Re: Renal Medicine Assoc. Clinic, Journal Center, Phase 2, ZAP D-17

Re: Renal Medical Associates Clinic Drainage Management Plan and Conceptual Grading Plan

C1.0
Conceptual Grading Plan

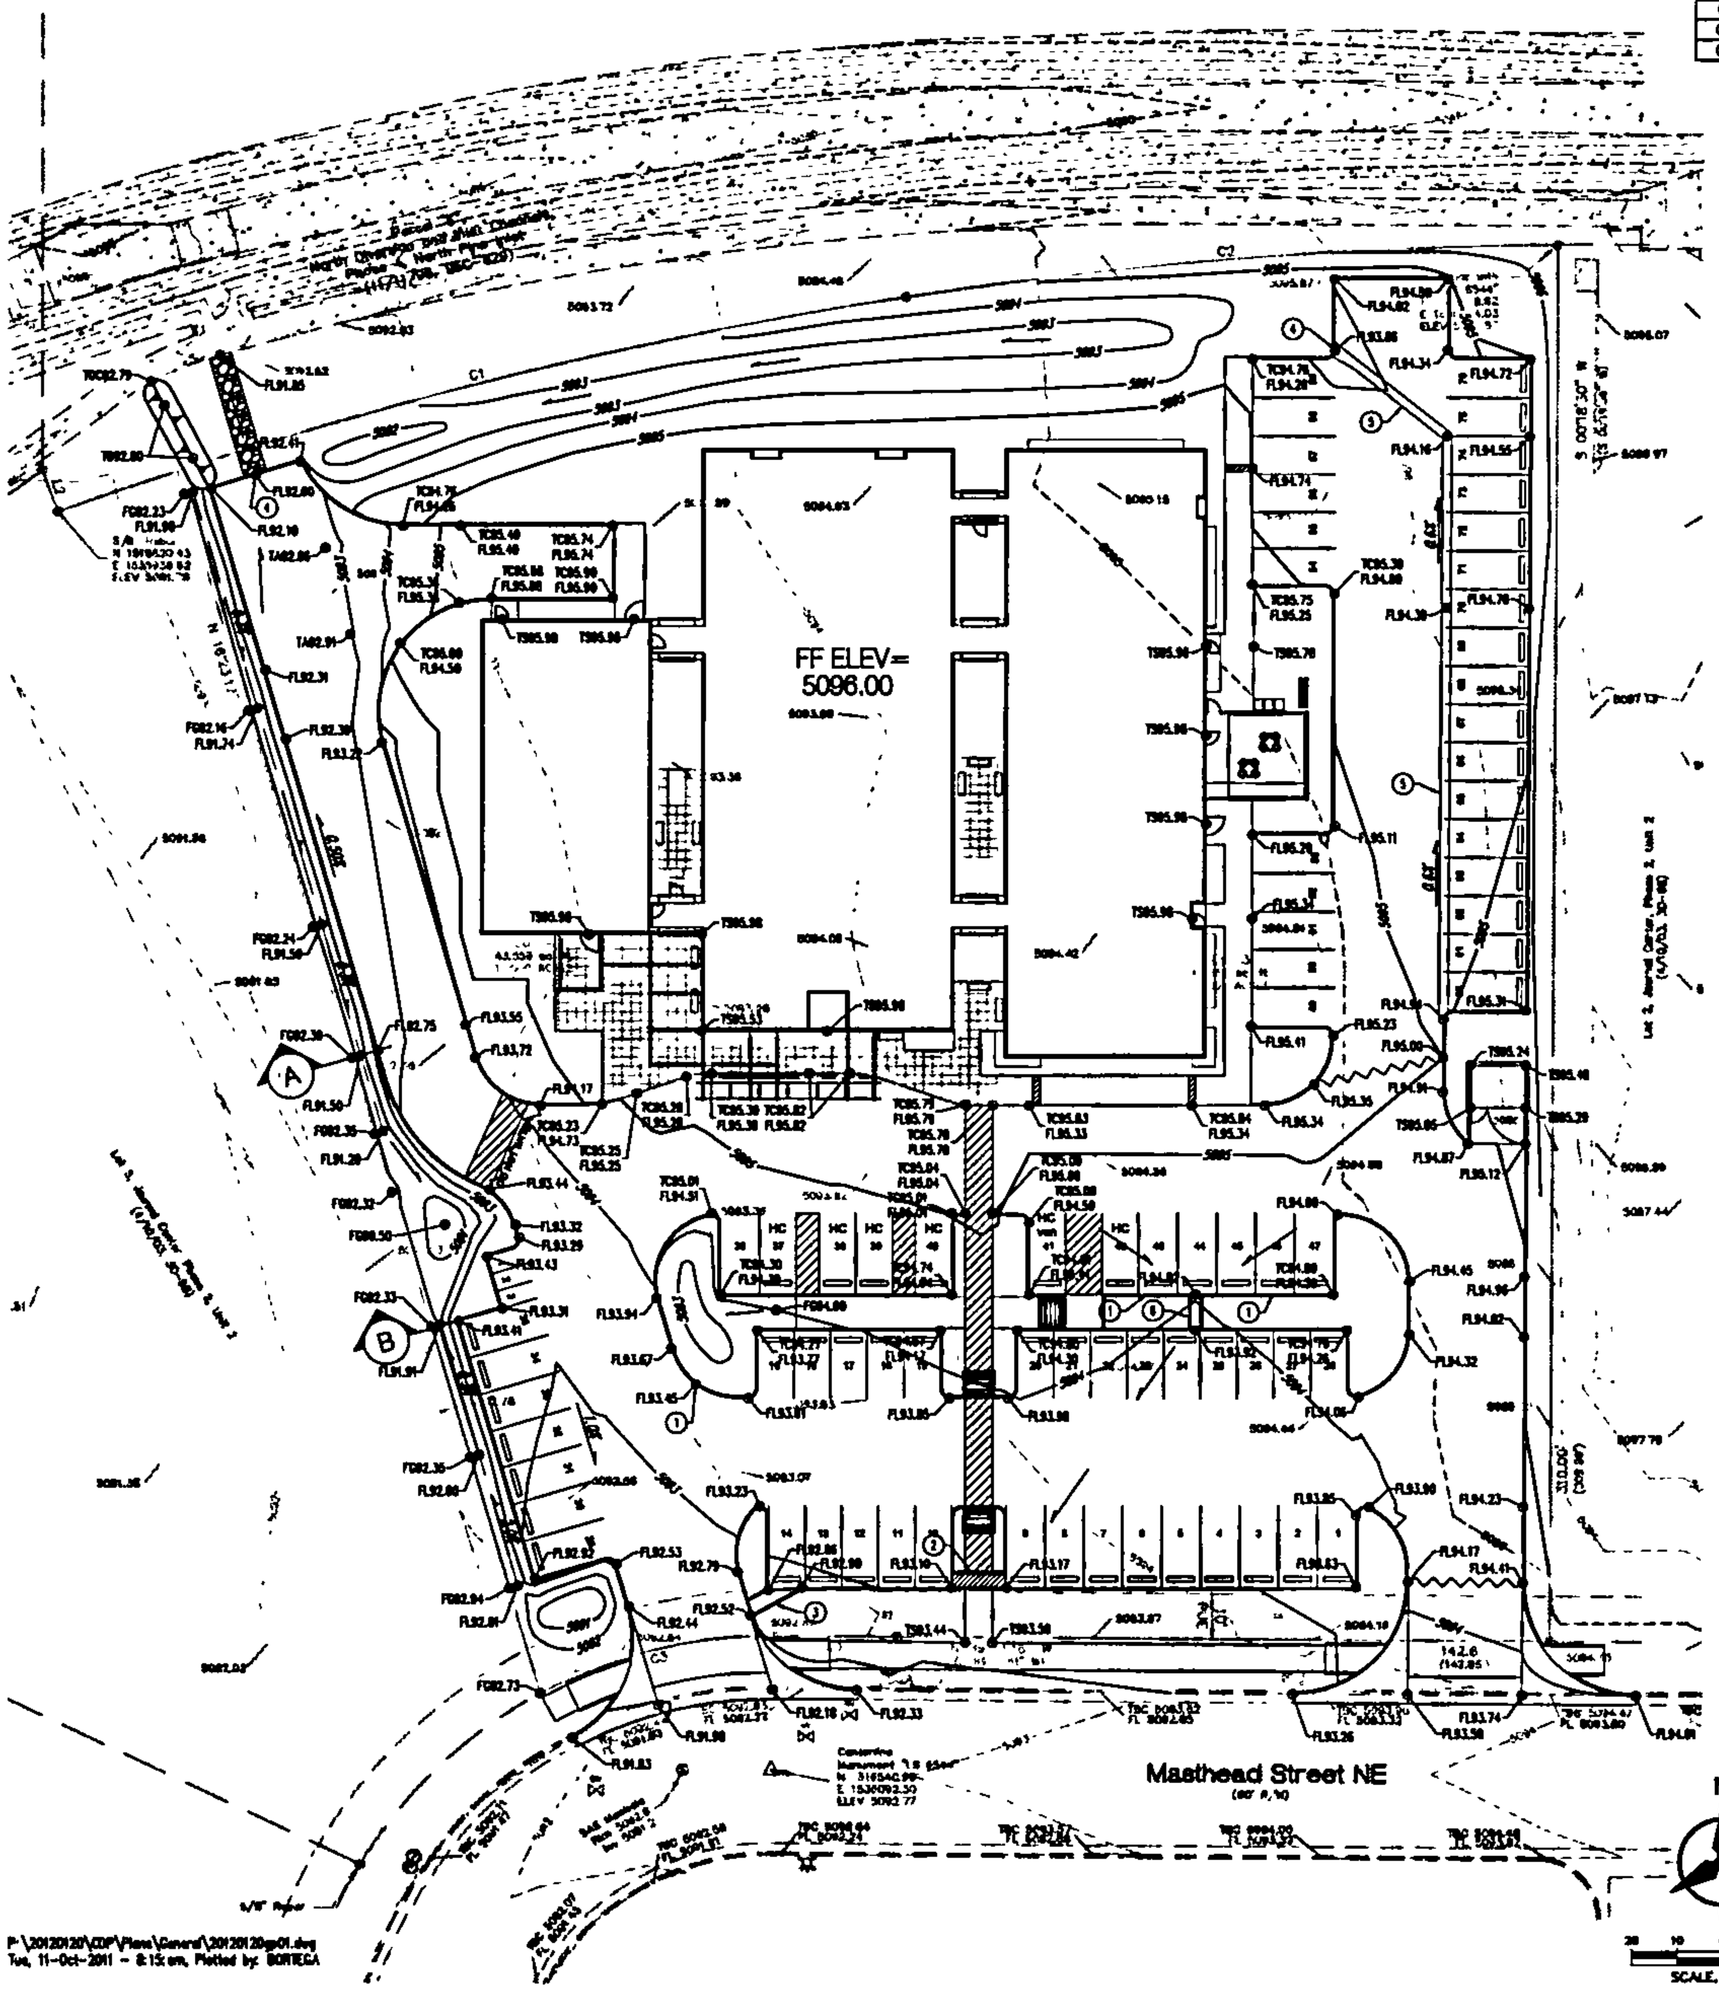
Based upon the information provided in your submittal received 9-19-11, the above referenced plan is approved for Site Development for Building Permit action by the DRB with the following condition:

- A cross-lot drainage easement for the benefit of Lot 3A is platted due to Basin 3 draining across Lot 4A.

When submitting for Building Permit, please address the following comments:

- Provide grades along the western property line so the grade of the tie slope can be determined.
- Please depress the eastern parking island.

C **STORMWATER TRASH SCREEN (SECTION)**

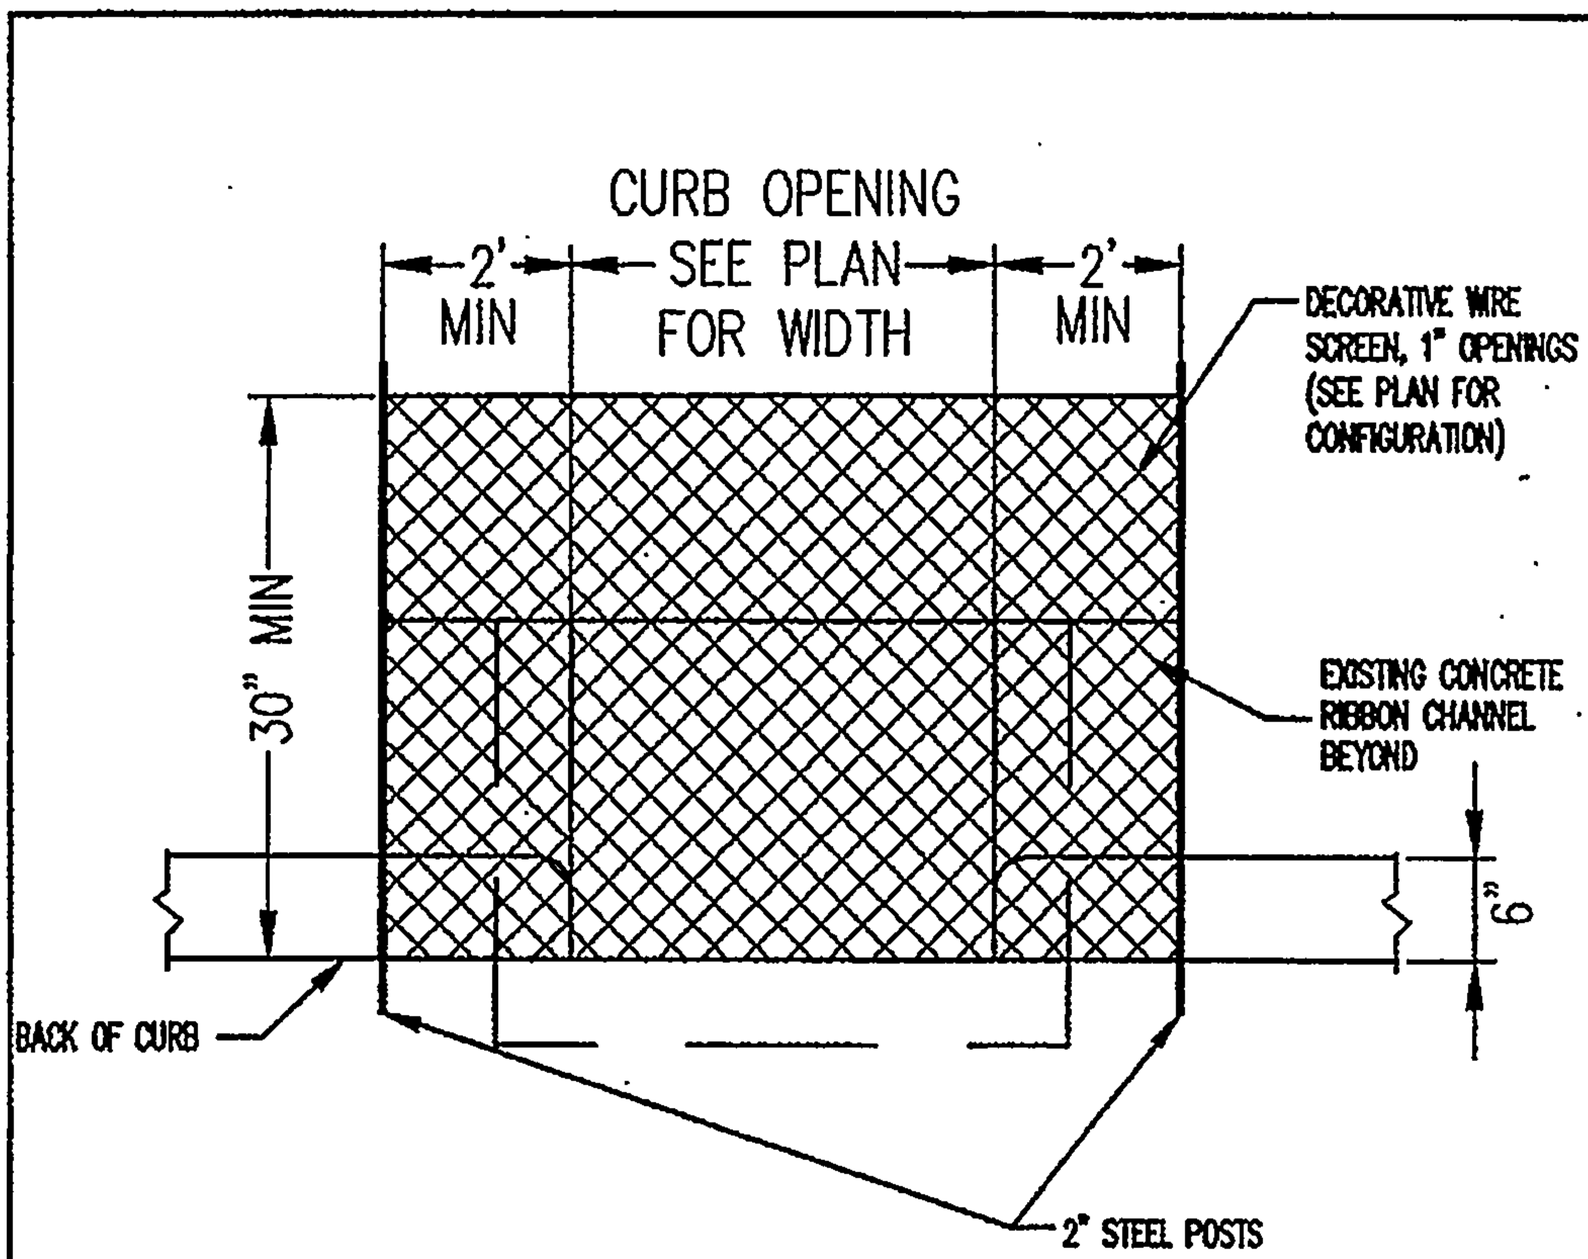
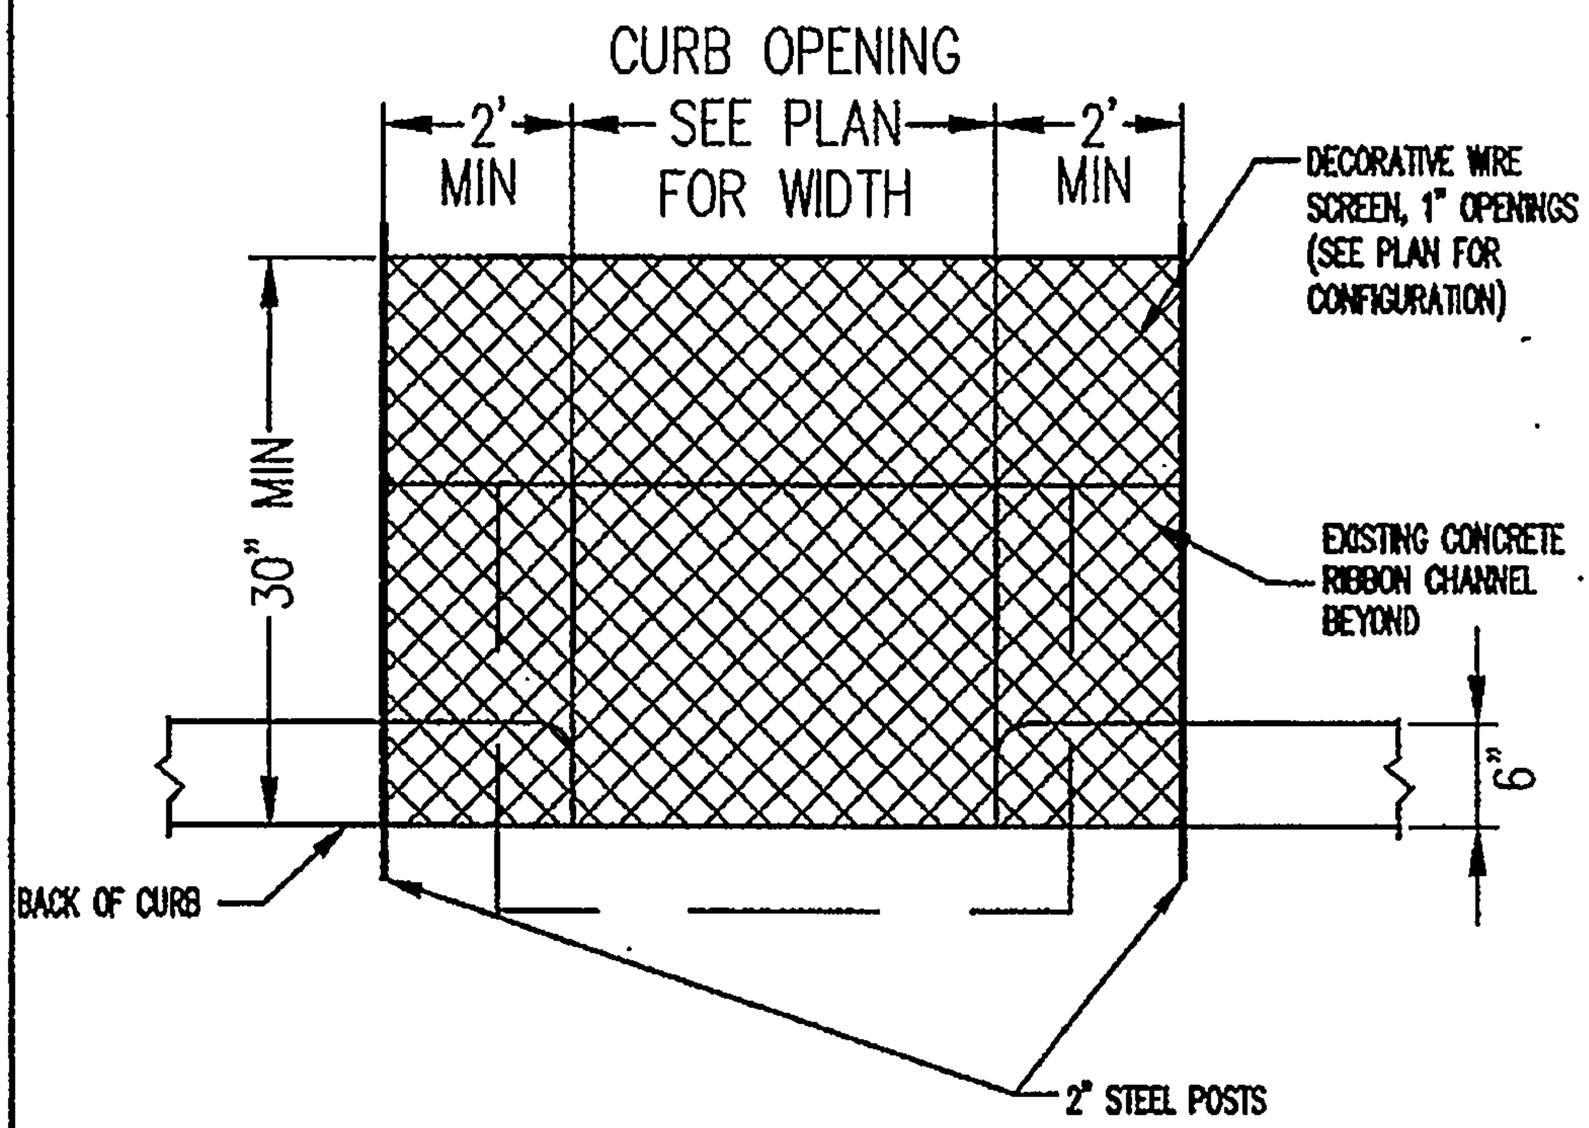
I reviewed the plan and approve the drainage concept. I would like to see a detail of the curb screens that will serve to collect onsite debris. I have attached two details of screens that have been used for commercial developments. The first one is on a rundown to the North Pino Arroyo east of Tiburon St. The height can be lower , and I don't think you will need 2' overlap on the curb for the smaller flow rates from this site. The second one has been used on a couple of developments in Journal Center that flow to the North Pino Arroyo. You don't need the gravel trench in front of the screen. Also, disregard the pond call-out.

1 SKA-05 East Parking Revisions

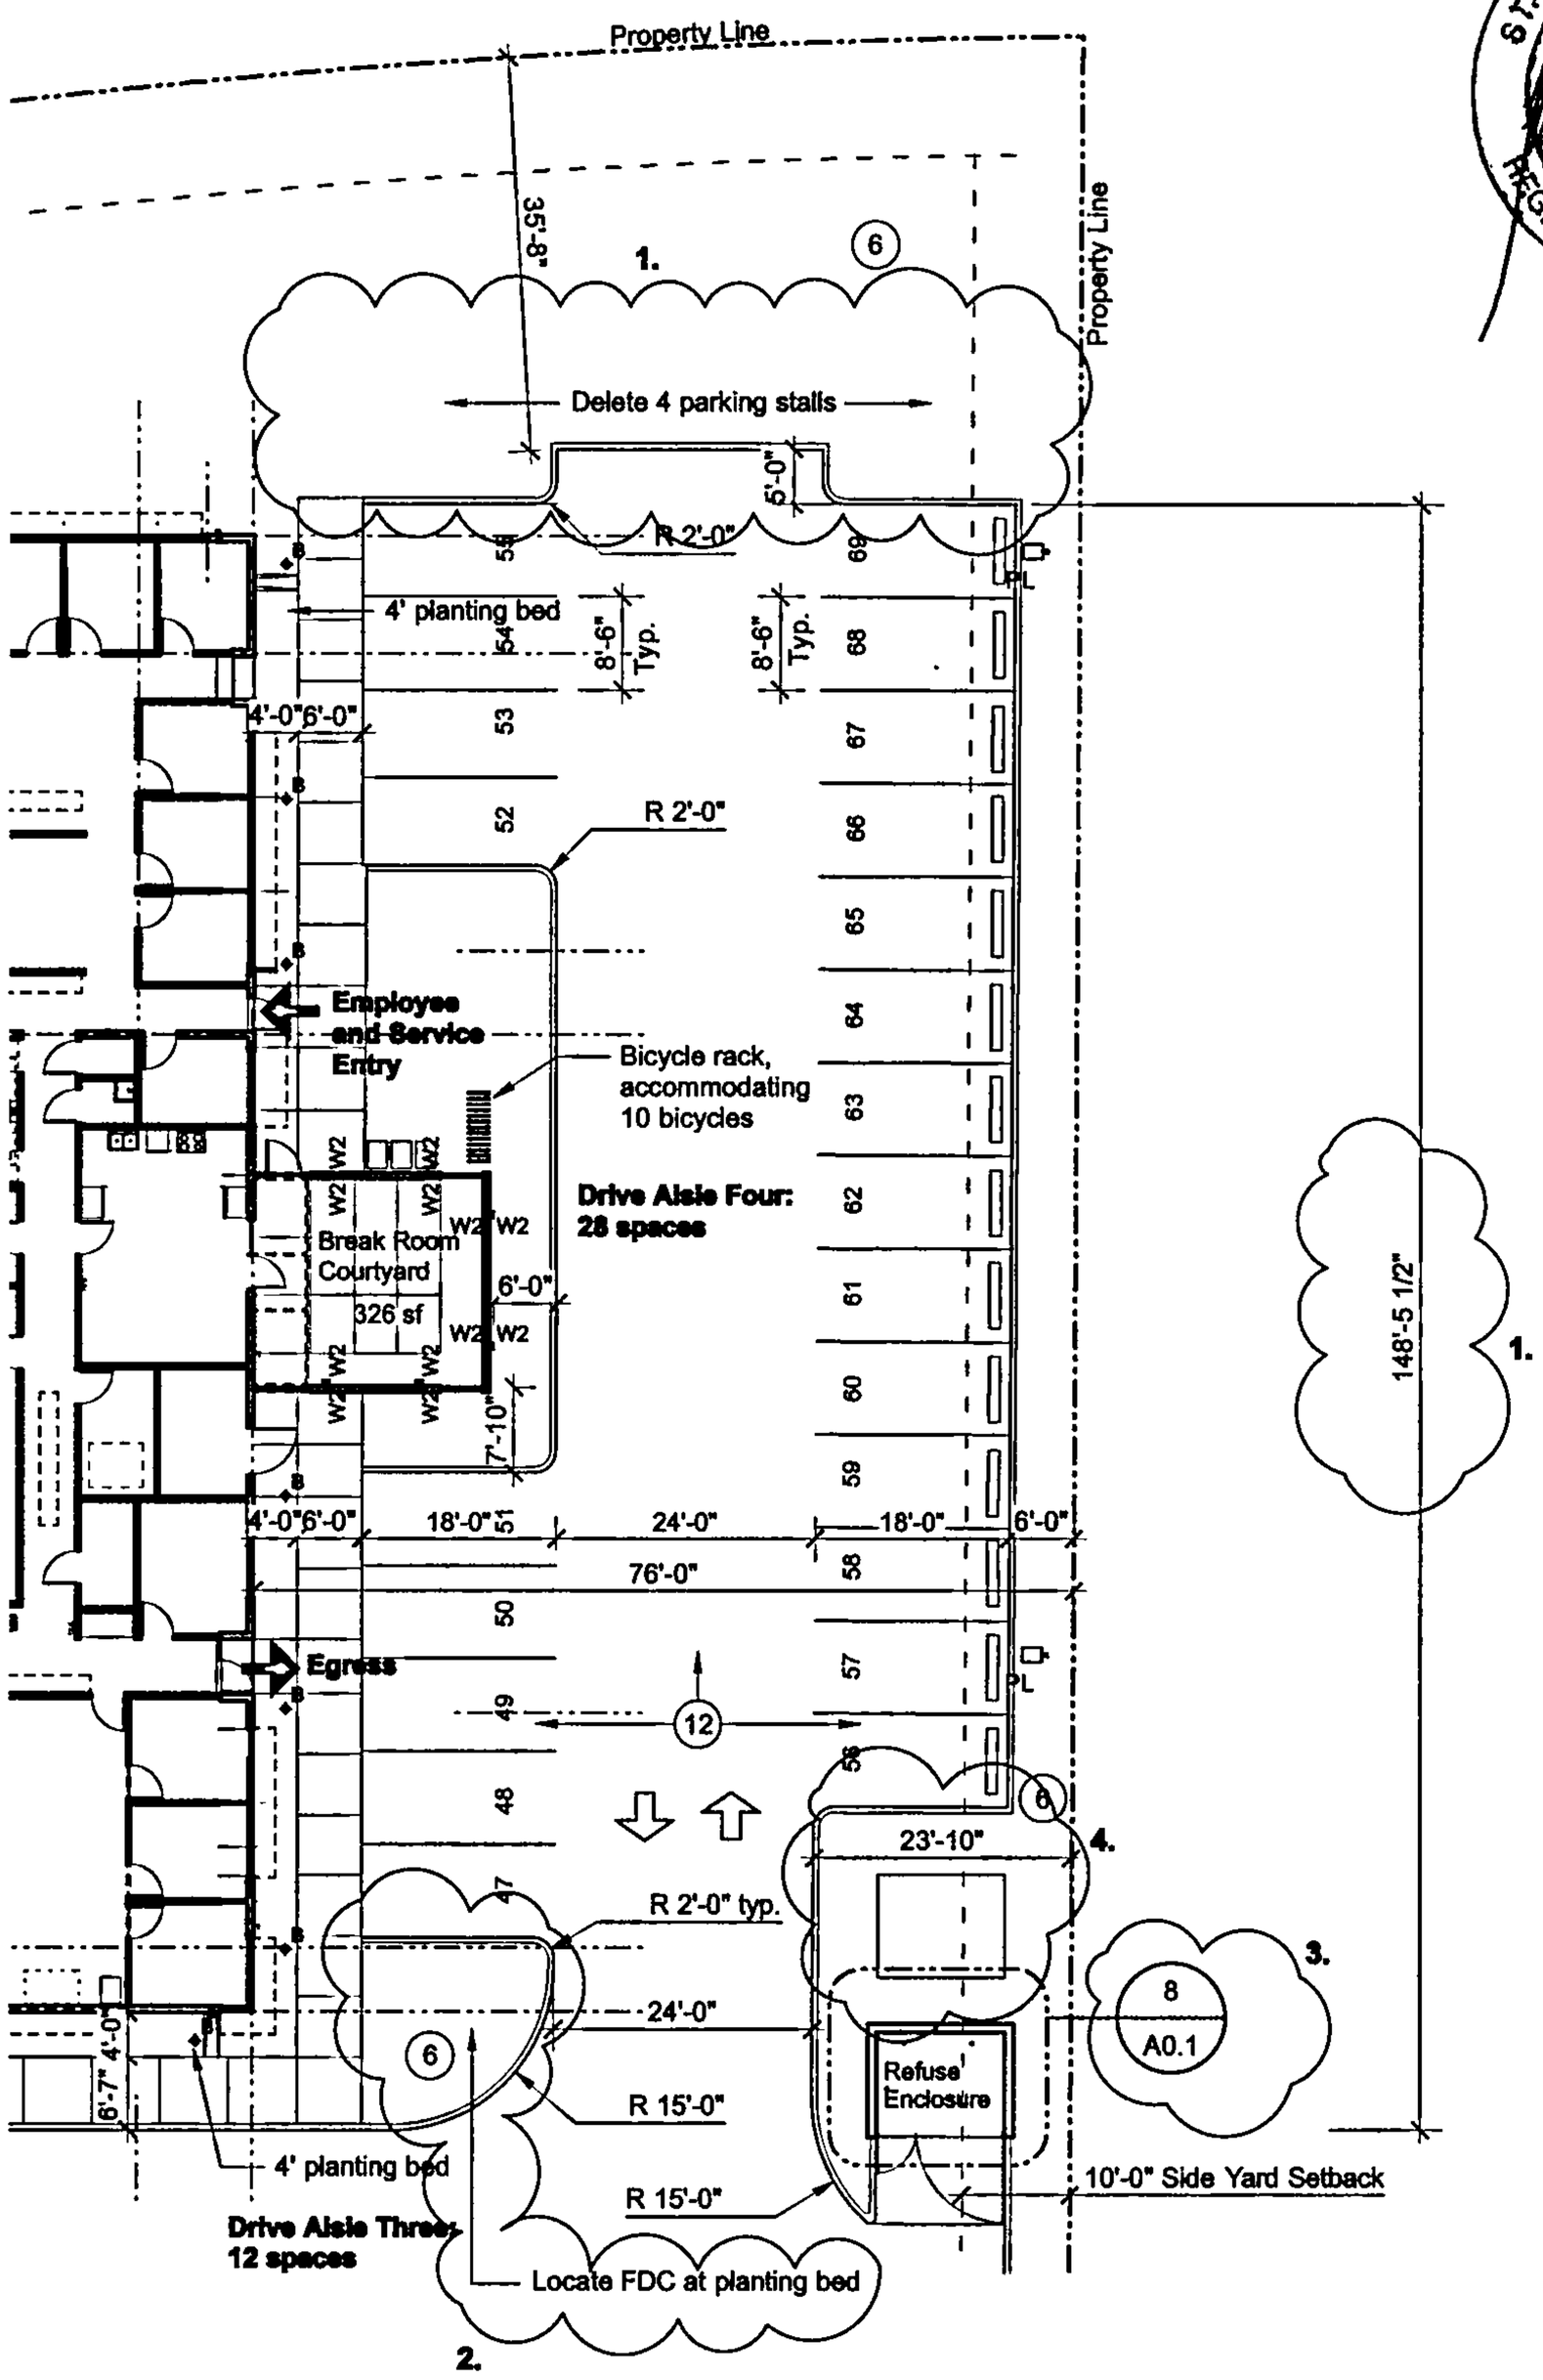
Reference: Sheet A0.1

Make the following changes to A0.1, Site Plan:

1. Delete 4 parking spots and shorten parking lot as indicated.
2. Relocate FDC to planting bed. Provide bollards for protection of FDC.
3. Revise detail marker for Refuse Enclosure drawing.
4. Delete 1 parking spot, provide pad for PNM transformer.
